BOOSTXL-DRV8305EVM board

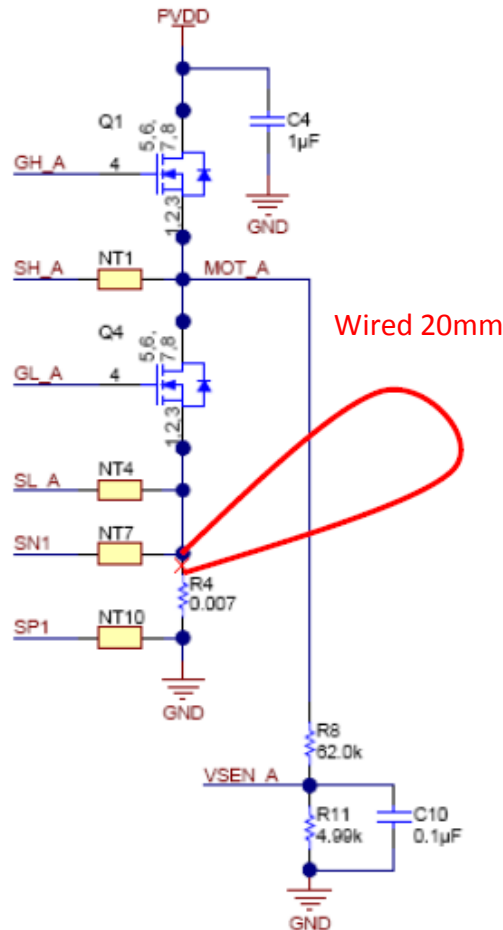
When I drive motor,
The difference of Q4-4(GL_A) waveform occurred
between normal board and wired(20mm) board.

If there are recommendation of distance between
Q4_1,2,3-R4,
could you teach me?

And, if there are recommendation of distance between
R4-GND plane,
could you teach me?

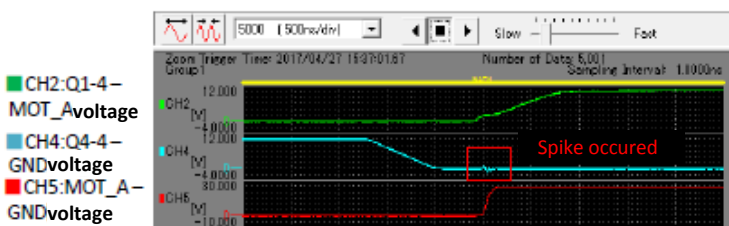
①Wired 20mm. Q4-4 rising edge

②normal board. Q4-4 rising edge

③Wired 20mm. Q4-4 falling edge

④normal board. Q4-4 falling edge
